Technical change to passive M23 FixCon distribution boxes

the passive distribution boxes with FixCon quick connection and vertical M23 connector will be changed. Please pass on this Product Change Notification (PCN) to your employees and, if applicable, to your customers.

Use of lead-free M23 connector with quick-connect contour

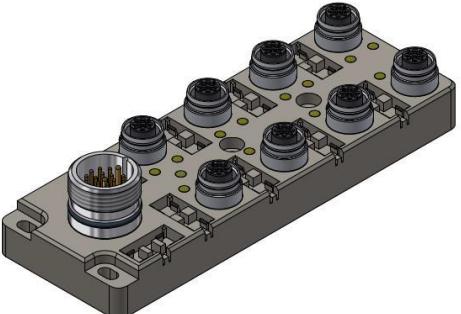
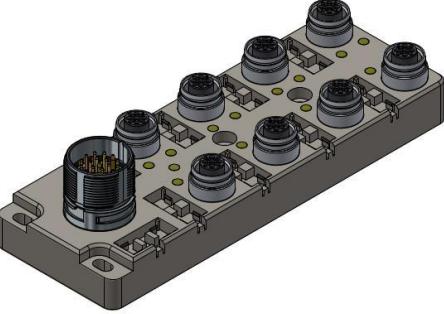
The M23 connector was previously designed as a leaded version with a standard M23 thread. As part of the product change, a lead-free M23 connector (without RoHS exemption according to 6c) is being used.

Previously, a lead-containing material was used for the M23 connector of the affected article. As part of the changeover, this will be switched to a lead-free material. Furthermore, the M23 connector in the new design has a modified contour, which enables the connection of M23 connectors with quick connection. The change results in deviations in the dimensions from the existing article. All other technical specifications remain identical.
